This Service Information bulletin supersedes SI B54 06 06 **dated November 2006**.

Water Leak from Panoramic Sunroof

E61 (5 Series Sports Wagon) Absorbent Pad Kit Installation

E53, E83, E61 Panoramic Sunroof Additional Sealing Procedure

Sealing Side Seams

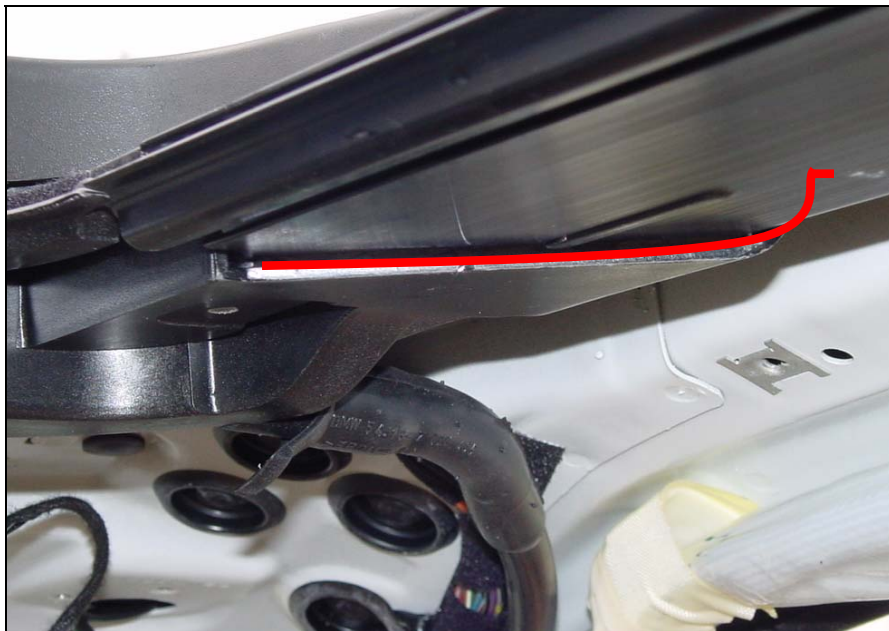
- Water may leak from the seam shown; where the side rail of the cassette meets the front section.
- Apply a bead of sealant, such as Sika-flex, along the complete length of the joint.
- This procedure should be performed for both the right and left side of the cassette.

Sealing Cable Channels

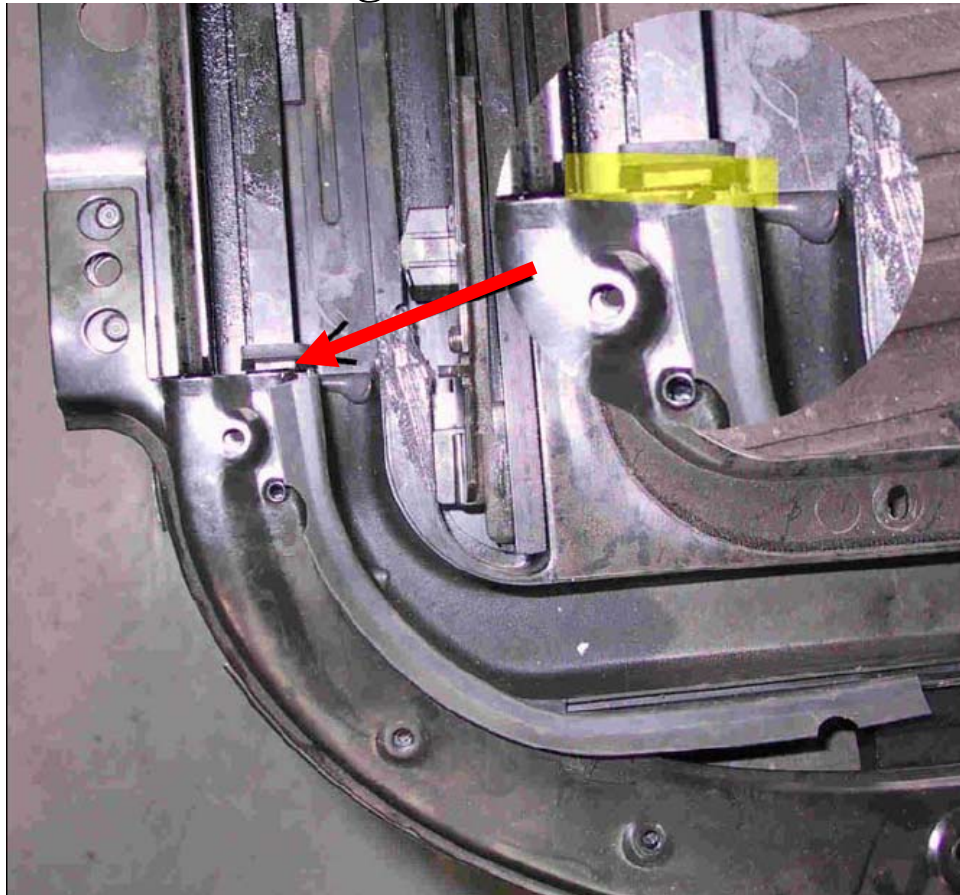
- Water may enter the cable channel through the area shown.
- With the cassette removed from the vehicle, seal the gap shown to prevent water from entering the cable channel.
- Apply a small amount of sealer, such as Permatex “Right Stuff”, or equivalent silicone sealer, to the gap.
- **Note:** Apply the sealer carefully as not to contaminate the cable itself with sealer, or obstruct the water’s path as it flows past this area.
- This procedure should be performed for both the right and left side of the cassette.
